Clocks 0.1-review - bottom assembly

75 x 70 mm / scale 1:1 / viewed from below (mirrored)

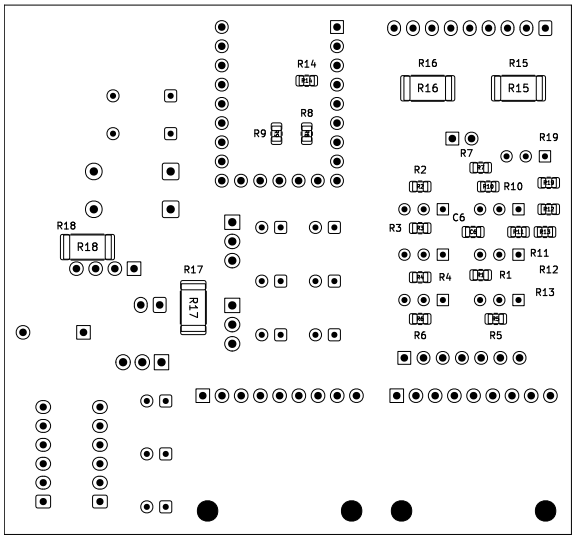
CAN / GPS underside: 12 mm above carrier (proposed).

Parts under these modules: maximum installed height 8 mm.

Check actual module undersides, supports and cable access.

MCP9600 holes support modules; enclosure mounts are not defined.

Review placement and cooling before ordering a prototype.
